Access Compliance Report

Public Rights-of-Way

(Curb Ramps)

Intersection ID: 49253		Main Street: LEGATO_LN		Cross Street: OAK_DR		Location: SE			
ADA ID: 19BF54CB770E		Ramp Type: Perp		Initial Pass/Fail: Fail		Overall Compliance: No		Severity Score: 10	
Codes/Mitigation Info/Possible Solution				Field Measurements/Component Compliance

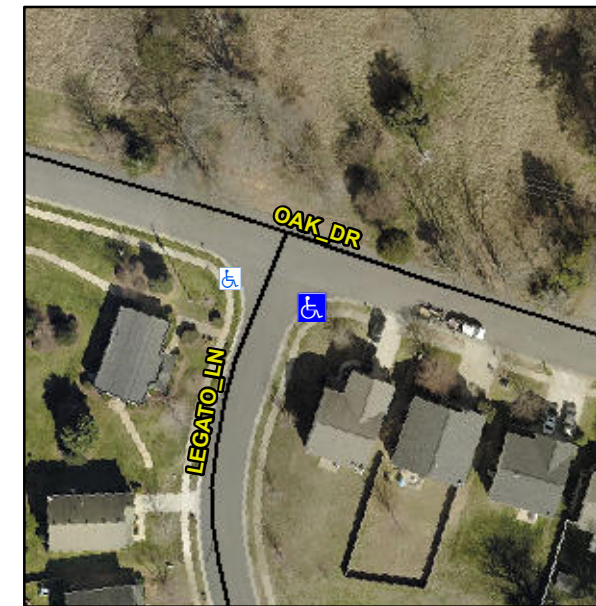
Not Found, R304.5.1, R304.5.3

Compliance	Description	Data	Compliance	Description	Data
N/A	Ramp Length (in)	46.5	Yes	Ramp Slope (%)	6.4
No	Ramp Width (in)	44.5	No	Ramp XSlope (%)	3.2
N/A	Flare Type LT	N/A	N/A	Flare Type RT	N/A
N/A	Flare Slope LT (%)	N/A	N/A	Flare Slope RT (%)	N/A
N/A	Flare Traversable LT?	N/A	N/A	Flare Traversable RT?	N/A
N/A	Landing Length (in)	N/A	N/A	DWS Provided?	N/A
N/A	Landing Width (in)	N/A	N/A	DWS Contrast?	N/A
N/A	Landing Slope (%)	N/A	N/A	DWS Length (in)	N/A
N/A	Landing X Slope (%)	N/A	N/A	DWS Full Width?	N/A
N/A	Landing Curb? (Y/N)	N/A	N/A	DWS Offset (in)	N/A
N/A	Shared Landing?	N/A			
N/A	Gutter Ponding?	N/A	N/A	Gutter Slope (%)	N/A
N/A	Gutter Lip Ht (in)	N/A	N/A	Gutter X Slope (%)	N/A
N/A	Painted X Walk1?	No	N/A	Painted X Walk2?	N/A
	X Walk 1 Direction	To NW		X Walk 2 Direction	N/A
N/A	X Walk 1 Width (in)	N/A	N/A	X Walk 2 Width (in)	N/A
	X Walk 1 Slope (%)	3.1		X Walk 2 Slope (%)	N/A
	X Walk 1 X Slope (%)	4.2		X Walk 2 X Slope (%)	N/A

Remove & Replace Entire Ramp.
